# Value Engineering Study Report

## Georgia Department of Transportation

STP00-1111-00(011) – P.I. No. 642220

SR 146/Cloud Springs Road from SR 1/US 27, East to CR 553/Lakeview Road  
Catoosa County

ALTERNATIVE NO.:  
**RD-1**

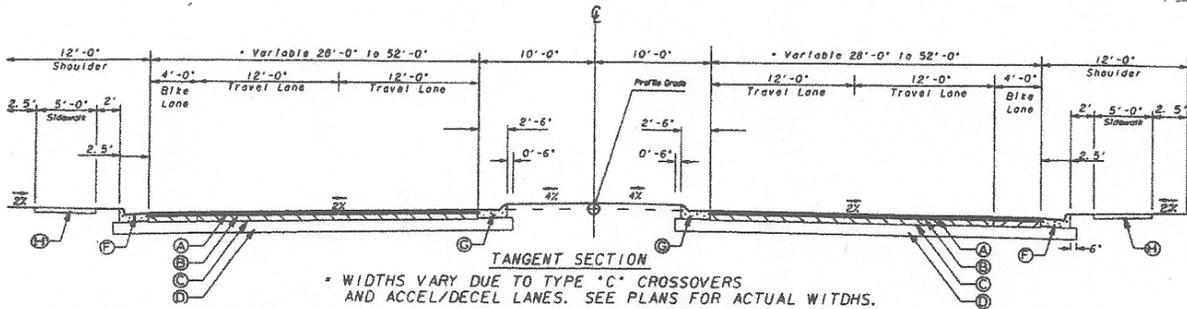
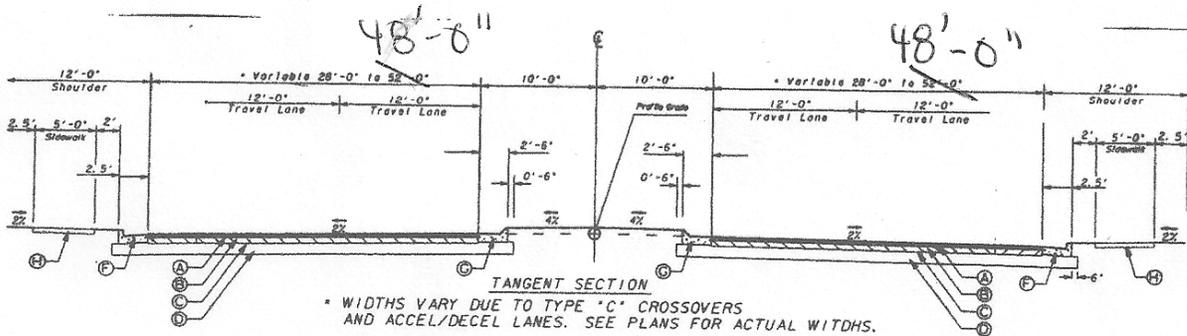
The original design calls for the construction of a 4' bike lane in each direction contiguous to the outside travel lanes.

The alternative design proposes deleting the bike lanes from the project.

The alternative proposes removing the bike lanes from the project entirely. There are no receiving bike lanes on either the eastern or western termini of the project. Also, the current adjacent construction project which is underway to the east does not provide bike lanes.

ALTERNATIVE NO.:  
**RD-3**

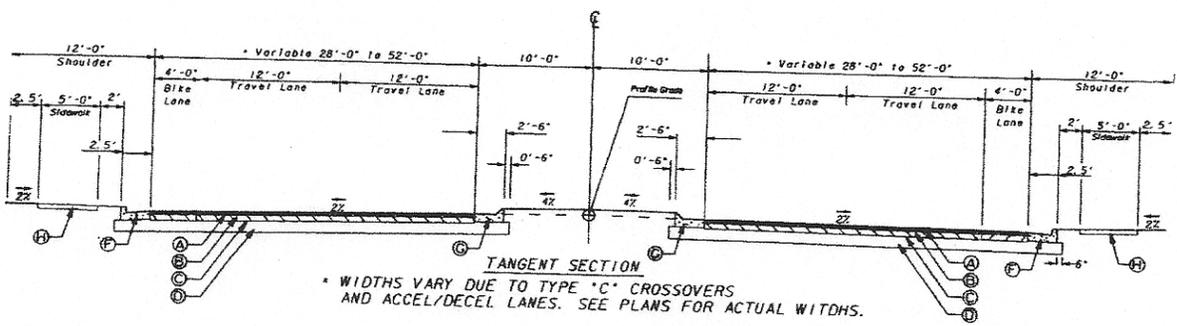
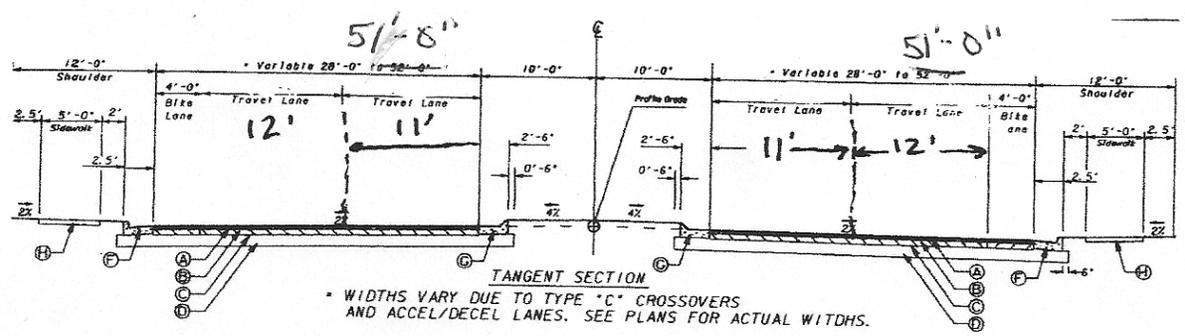
The original design proposes construction of two 12' travel lanes eastbound and westbound throughout the project.

The alternative proposes constructing a 12' outside travel lane, as well as an 11' inside travel lane throughout the project.

Reduction of width of travel lanes throughout the project would result in 2' of full build-up widening that would not have to be constructed. AASHTO's "Policy on Geometric Design of Highways 2004" states that 11' lanes are permissible. It also states that under interrupted – flow operating conditions at low speeds (45 mph or less), narrower lanes are normally adequate and have some advantages. (See Pages 472-473). The combination would construct 12' outside lanes to accommodate the local truck traffic, as well as allowing a greater turn radius to right-turning vehicles.

ALTERNATIVE NO.:  
**RD-4**

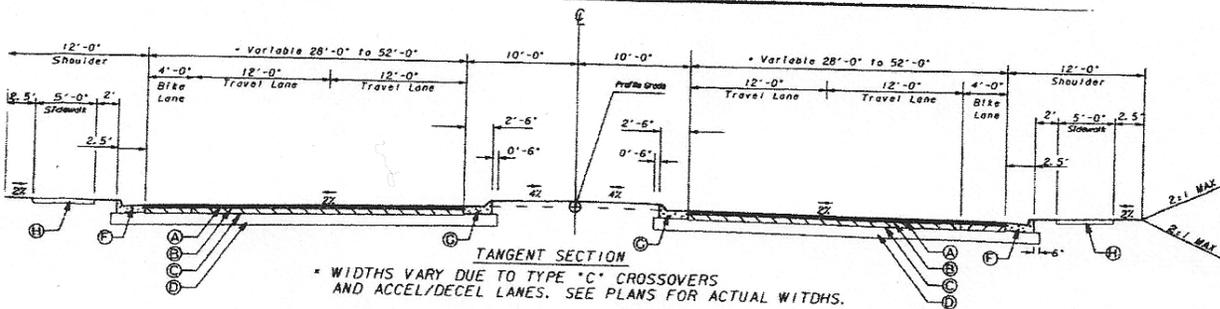
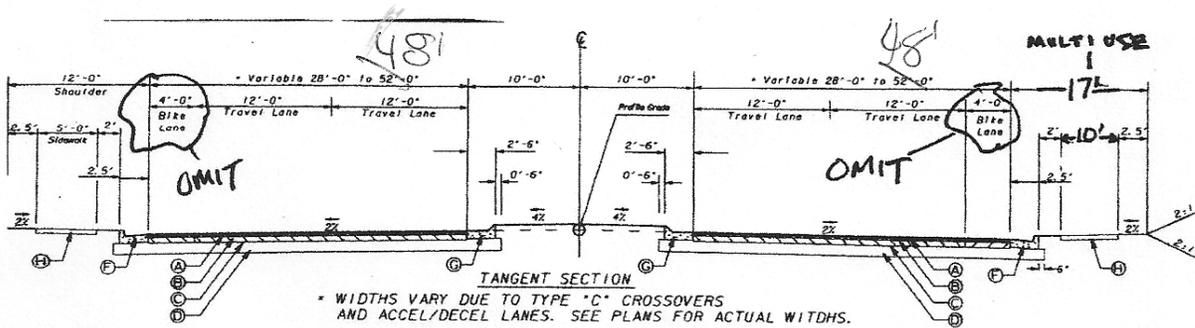
The original design calls for the construction of 2-4' bike lanes adjacent to the eastbound and westbound roadway. The original design also calls for the construction of a 5' sidewalk in each direction.

The alternative design proposes removing the bike lanes from the roadway section, constructing a 5' sidewalk in one direction and a 10' multi-use trail in the other direction.

Using a 10' multi-use trail in-lieu of bike lanes in the roadway should provide approximately equal functional capability. Bike lanes are not provided on this roadway

ALTERNATIVE NO.:  
**RD-8**

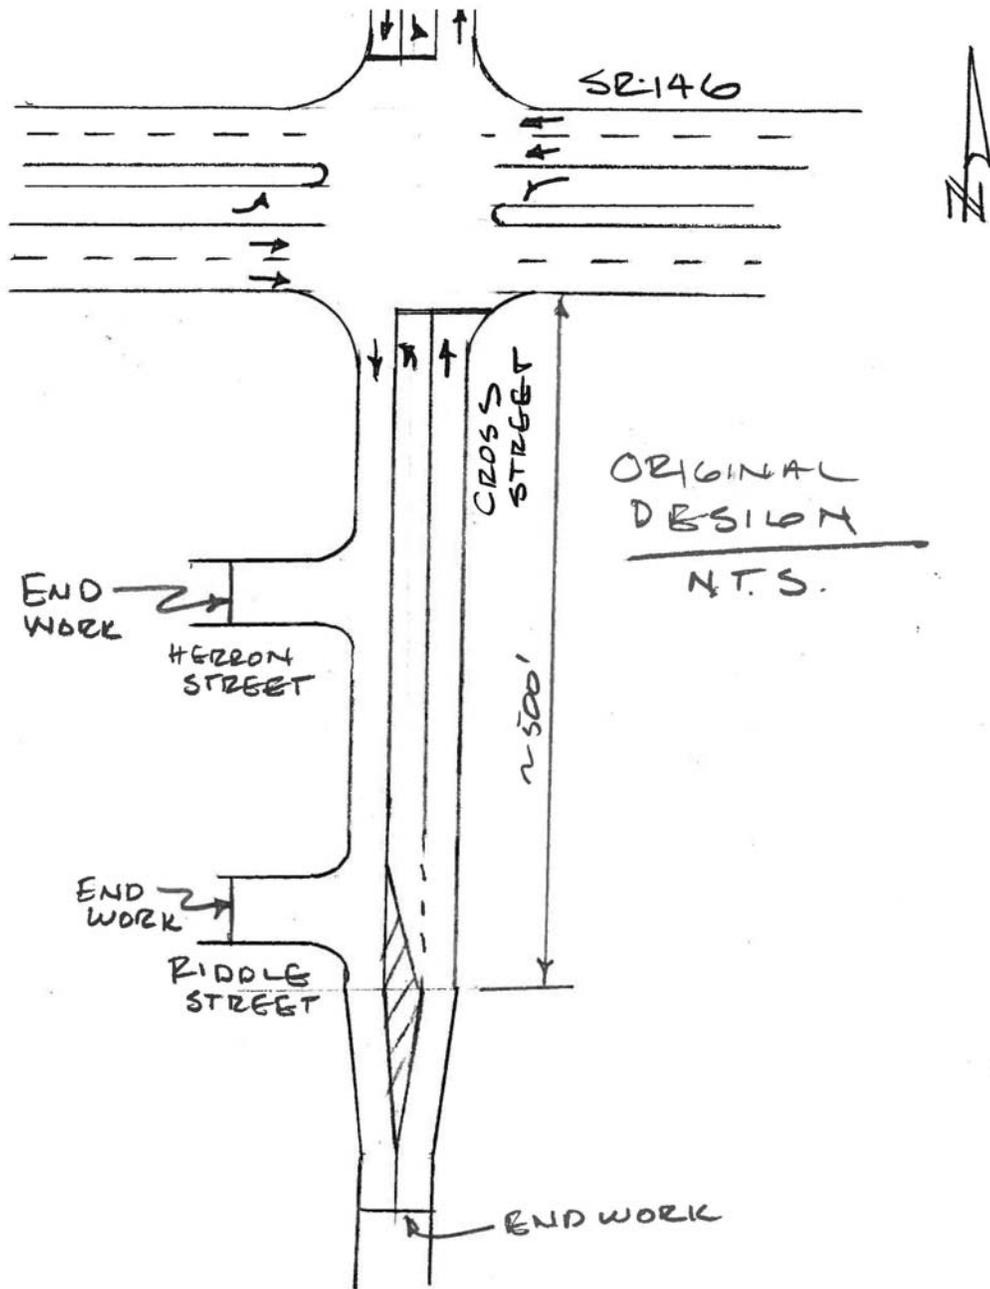
The original design proposes constructing approximately 500' of storage and taper for the northbound traffic on Cross Street entering SR-146.

The alternative design proposes reducing the proposed storage and taper for the northbound left-turn on Cross Street entering SR-146, to approximately 260'.

It appears that the design may be to provide additional storage bay of sufficient length to allow left turning vehicles to “jump the queue” of the vehicles proceeding northbound on Cross Street. For higher volumes this would be desirable to avoid blocking this thru movement. However, the left-turn movement from Cross Street northbound onto SR-146 has a Design Year (2032) DHV of 25 VPH. This level of usage typically does not require extended storage and that for this projected movement, one would anticipate that a minimum design would be adequate.

ALTERNATIVE NO.:  
**RD-12**

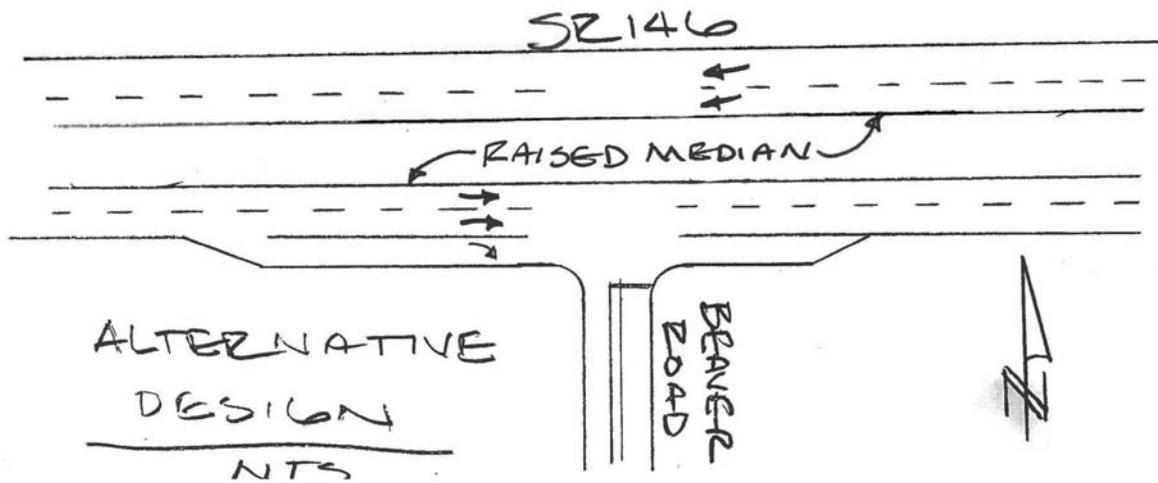
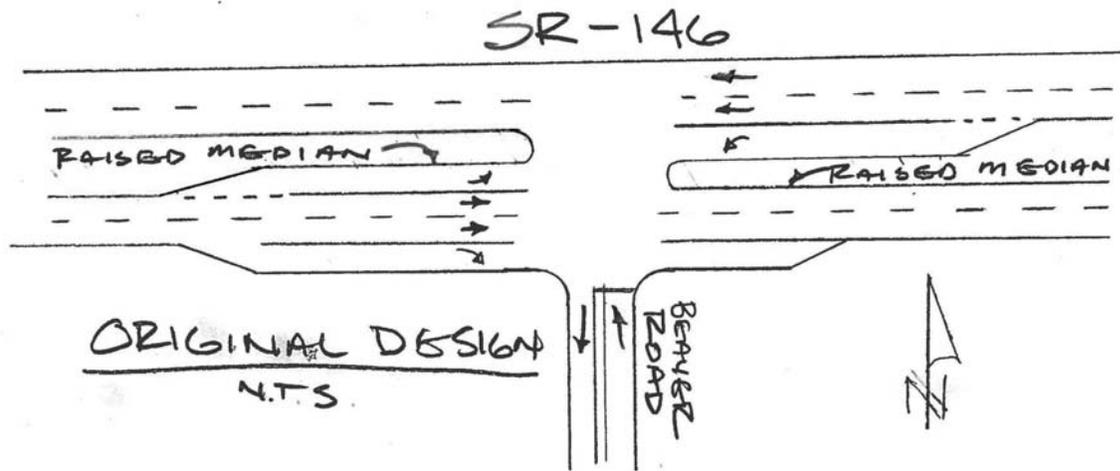
The original design proposes full median openings at all the major cross-streets and several minor cross-streets.

The alternative design proposes eliminating the median openings and turn lanes at CR-57/Beaver Road, the entrance to Park Lake Apartments, and Linda Lane.

CR-57/Beaver Road has a Design Hour Volume of 100 vehicles in the design year (2032); Park Lane apartments and Linda Lane traffic projections were not provided. The traffic volumes on SR-146 in the vicinity of these three roadways range from ~33,000 VPD to ~38,500 VPD in the design year (2032).

The introduction of full median openings at low volume (100) side streets which are unsignalized may adversely affect the operational efficiency of the main roadway.

ALTERNATIVE NO.:  
**RD-14**

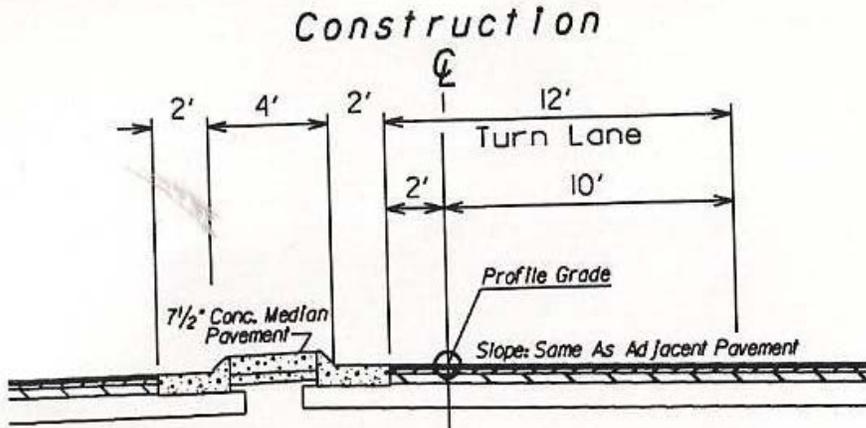
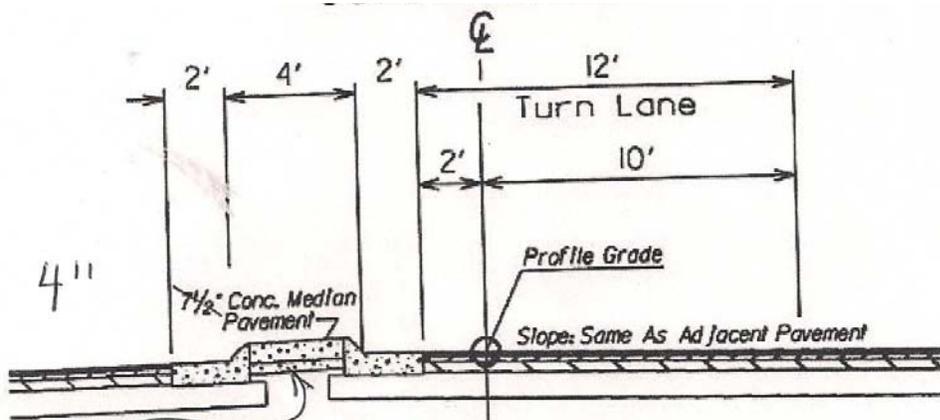
The original design calls for a 7.5" thick concrete median to be constructed throughout the project.

The alternative proposes using a 4" thick concrete median in lieu of the 7.5" concrete median thickness utilizing borrow material to make up the vertical differential.

ALTERNATIVE NO.:  
**RD-18**

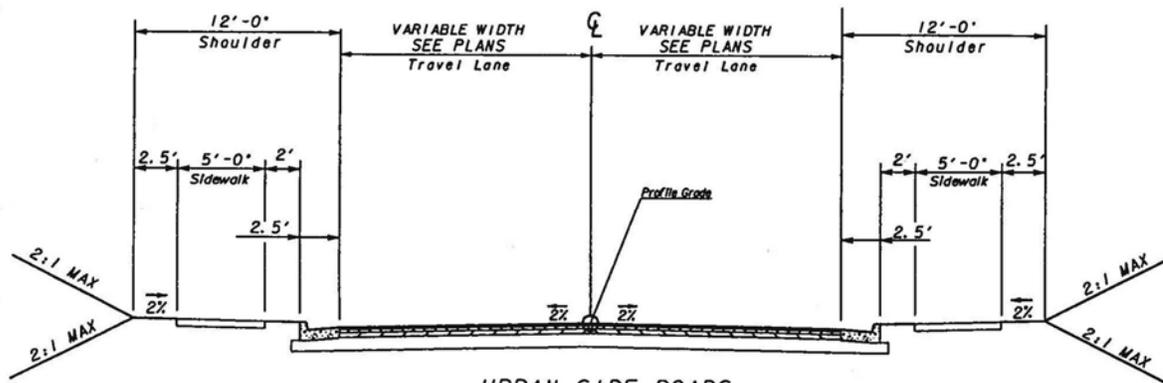
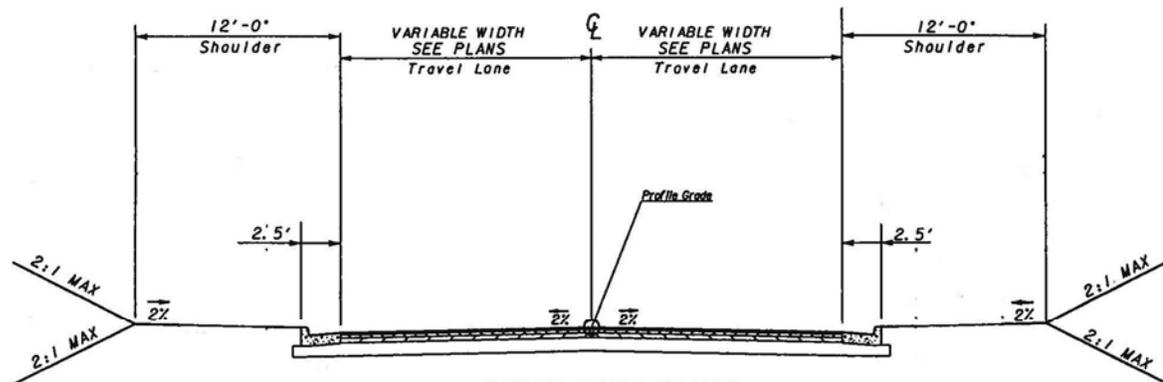
DESCRIPTION: Eliminate sidewalks on side streets: Cross Street, Fant  
Drive and Cedar Lane.

ALTERNATIVE NO.:  
**RD-19**

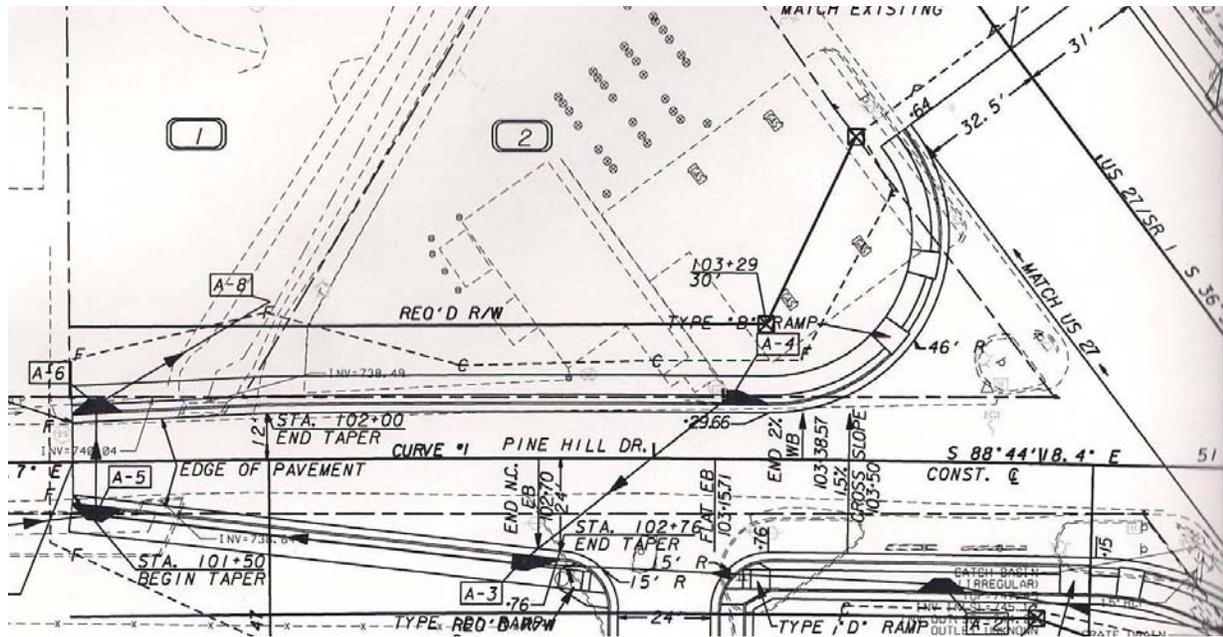
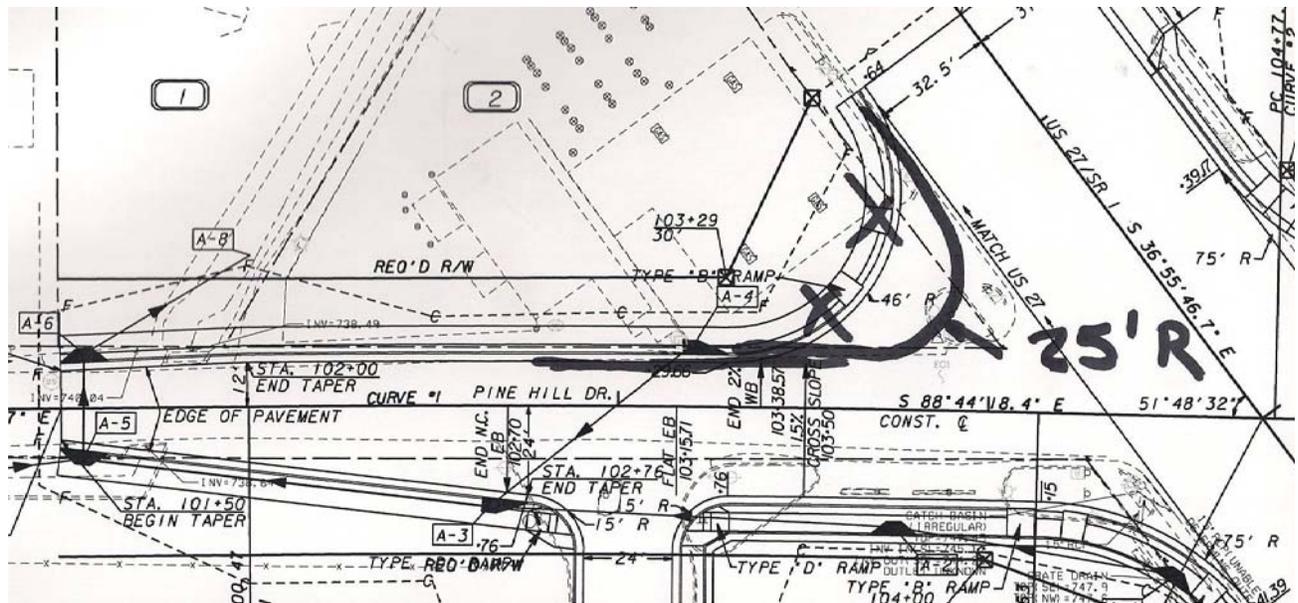
The current design does propose to keep the new pavement in line with the existing pavement, however, by increasing the radius of the curve and the addition of a new sidewalk with handi-cap ramps results in the taking of an existing business. The existing intersection is at 51 degrees with US 27 and the current design maintains this angle so as to minimize the adverse affects of the project. This minor change would significantly reduce the impact and save a business and about \$550,000. Truck access would remain as it presently is accommodated.

ALTERNATIVE NO.:  
**RD-21**

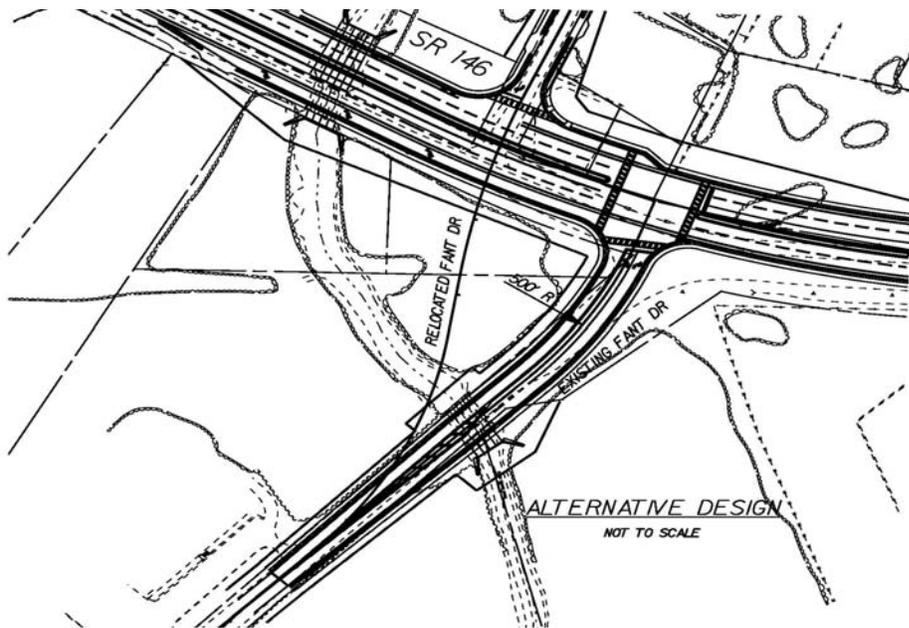
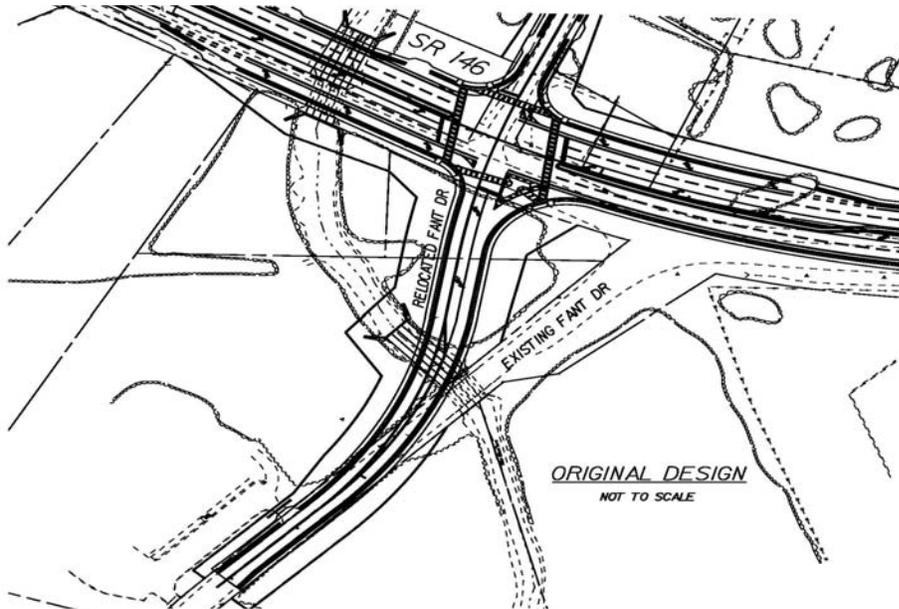
The proposed design improves the intersection angle of Fant Drive and realigns it with McDonald Drive. Aligning side roads to reduce the number of intersections is normally desirable. Traffic counts were not provided for McDonald Drive but it is anticipated that they would be much less than CR 57 which had a Design Year (2032) DHV of 680 VPD. Realigning Fant Drive to provide a median opening for McDonald Drive would provide minimal operational benefit and has notable impacts to R.O.W. costs, a major drainage structure, and wetlands. By simply improving the Fant Drive intersection angle and more closely following the existing alignment without matching McDonald Drive, these impacts are greatly reduced.
